See comments from  
engineering in blue

# PRELIMINARY/FINAL DRAINAGE REPORT FOR ROMENS SUBDIVISION

OCTOBER 2020

Romens Plan: 96cfs Subcritical 10/12/2020  
US of Culvert

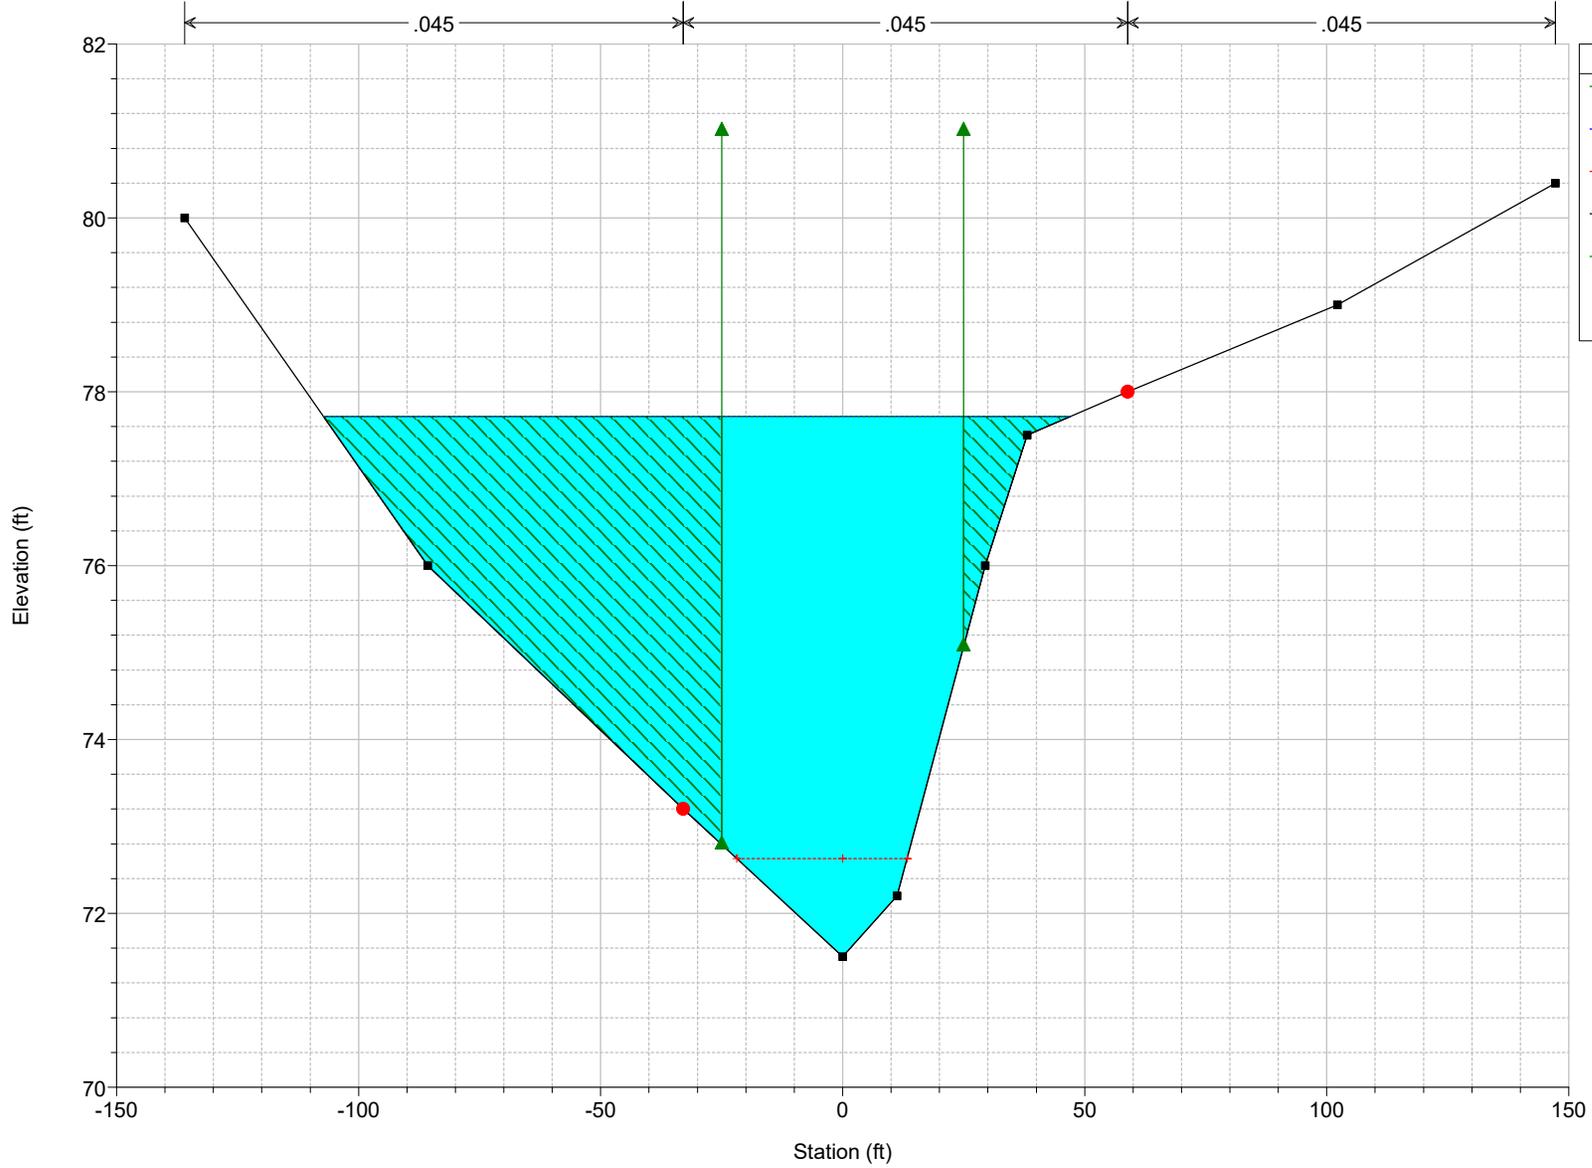
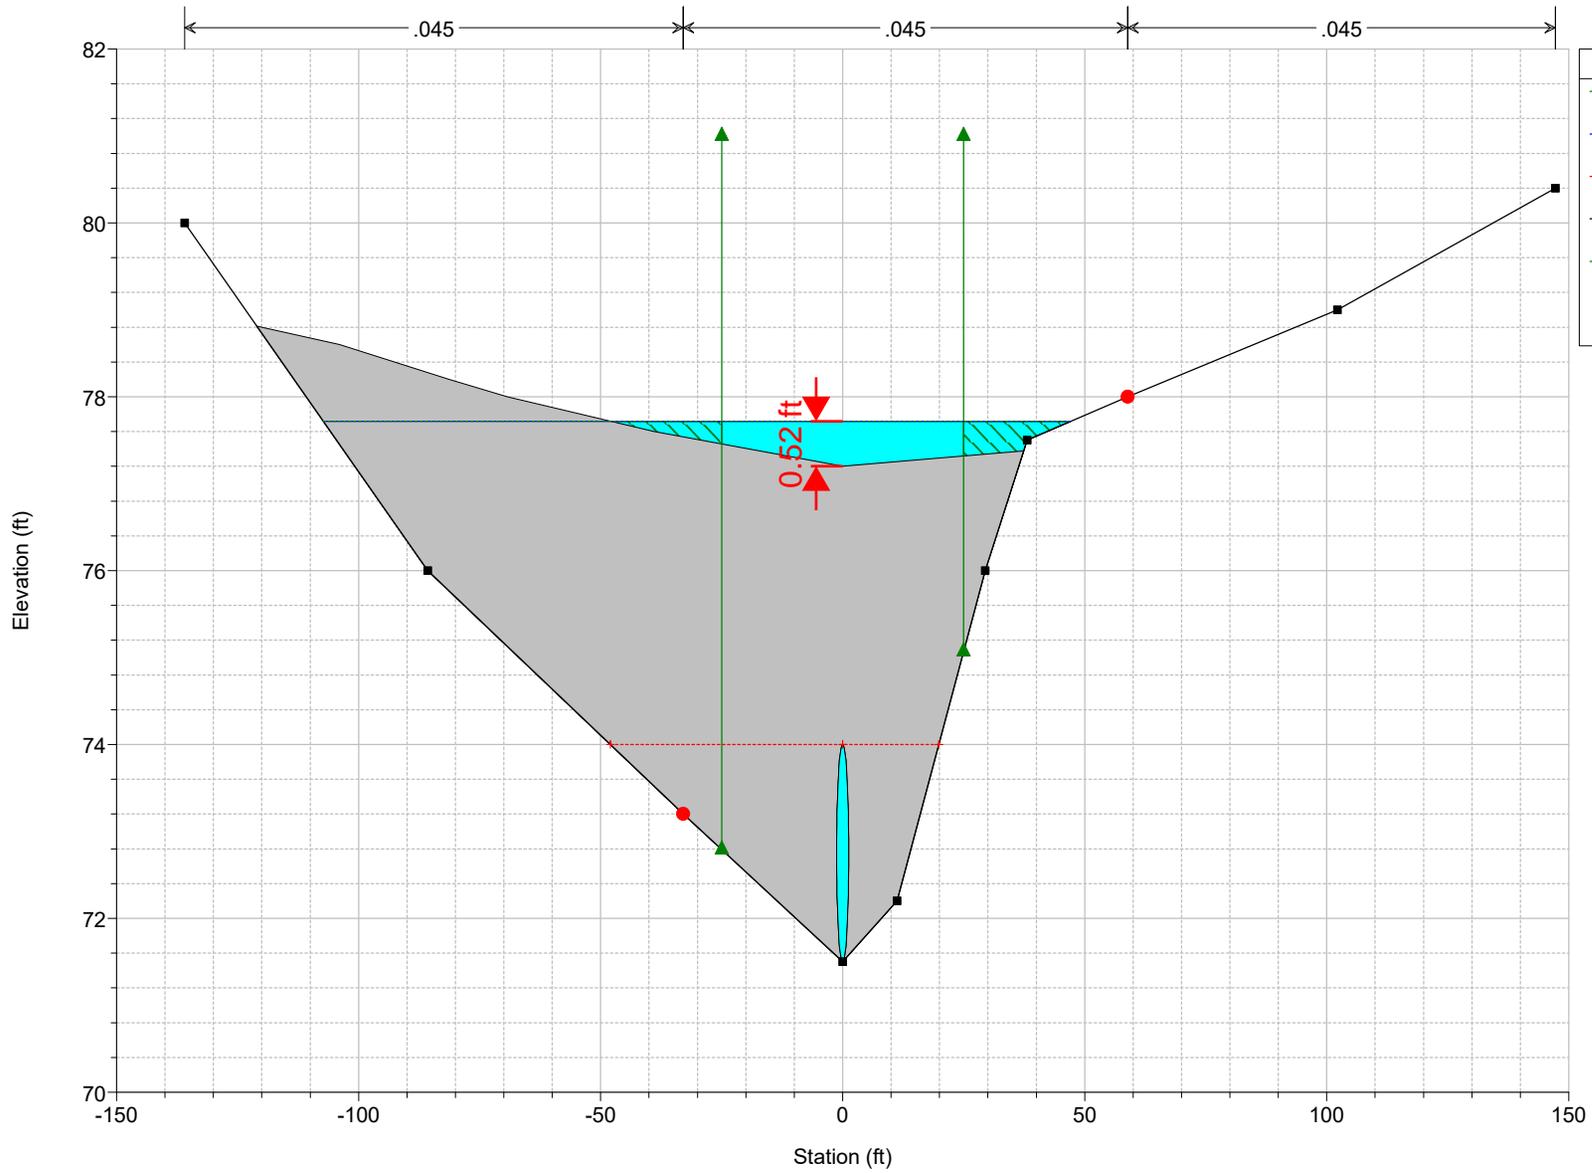
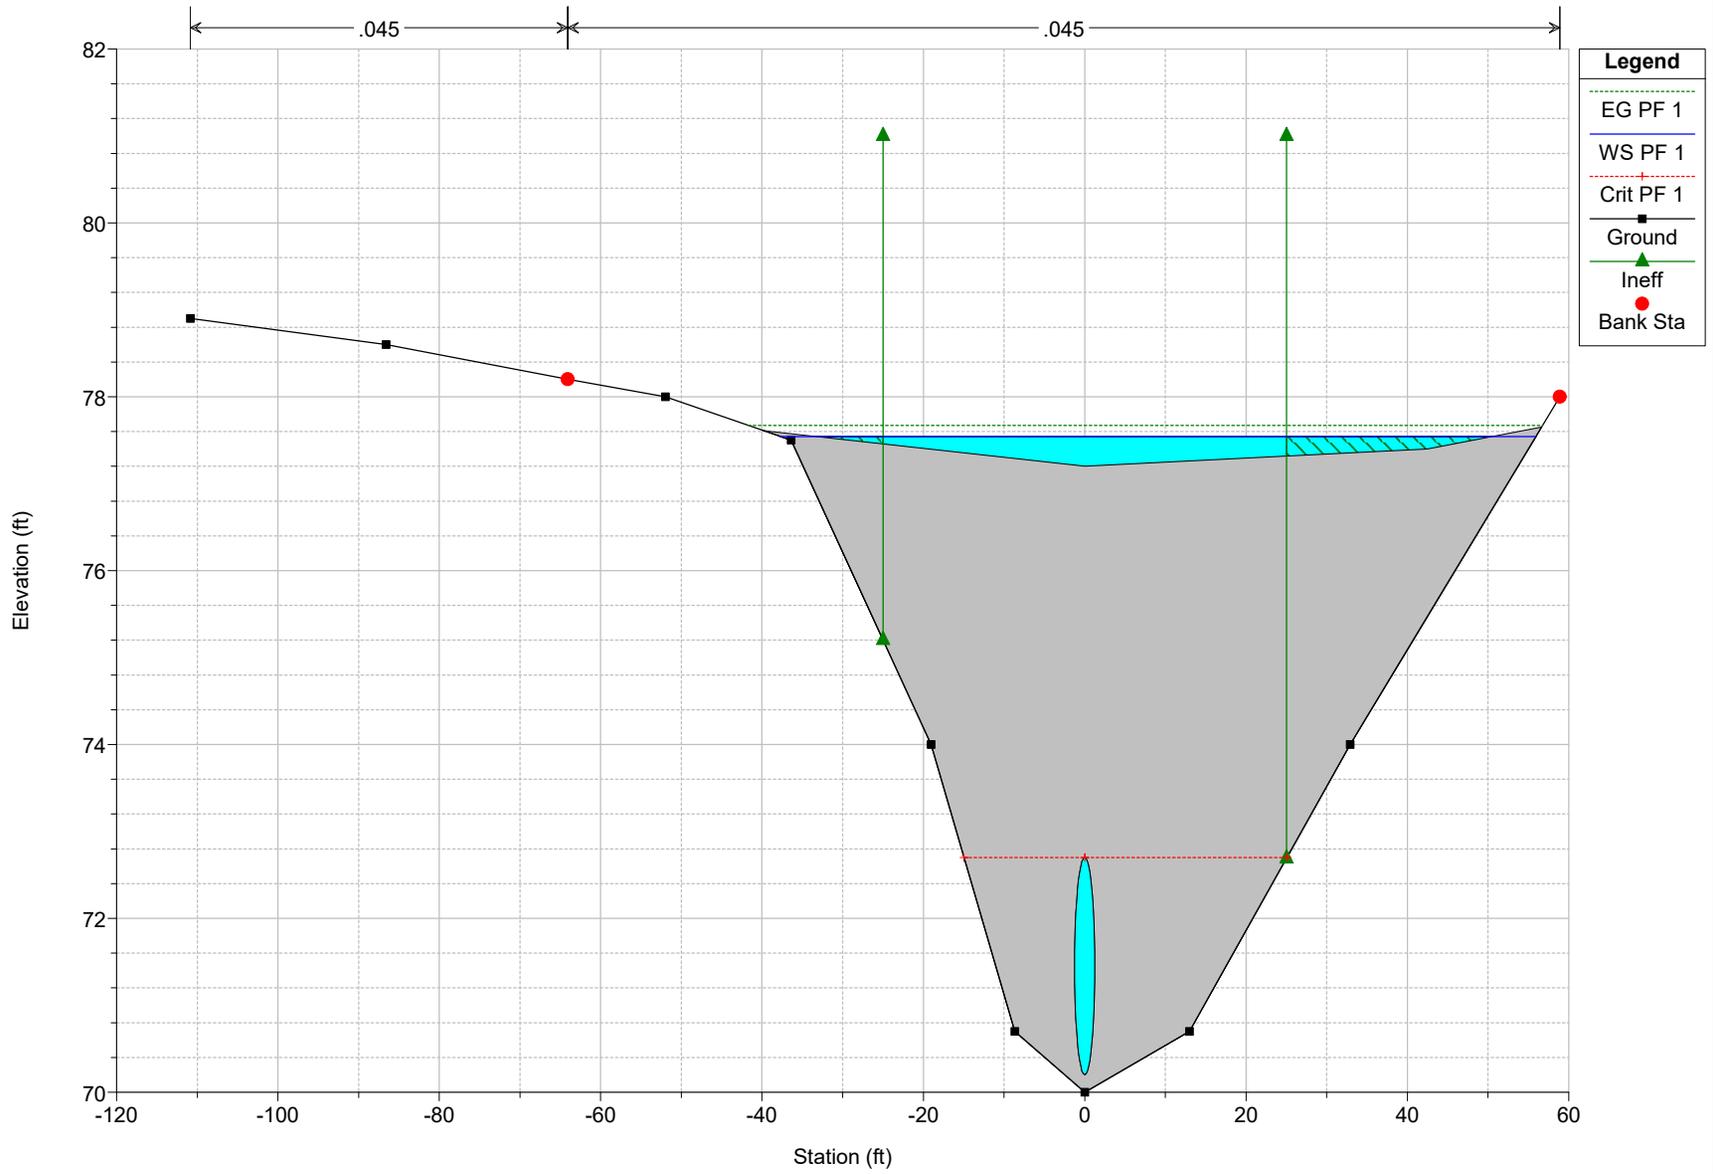
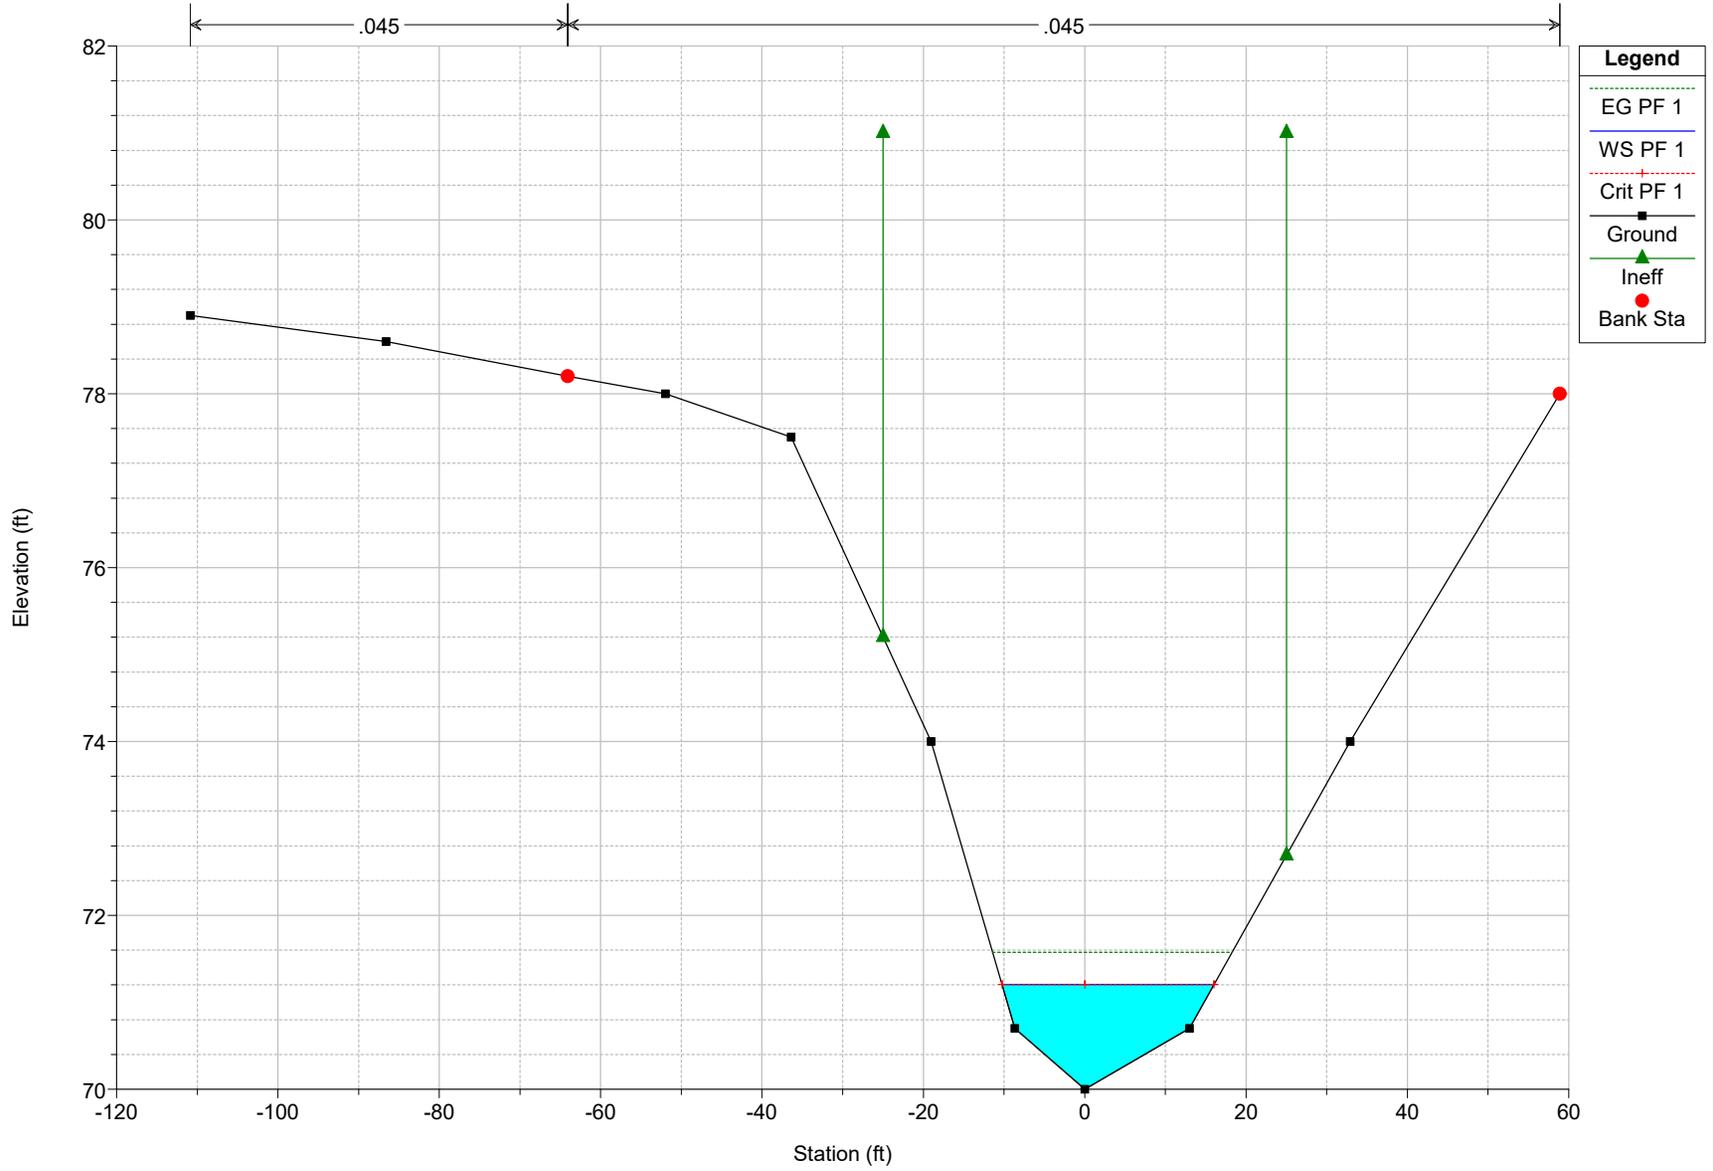
provide the downstream boundary condition used and describe in the narrative.

Provide the table for the other cross sections.

Provide label identify which cross section these are. Typ. All
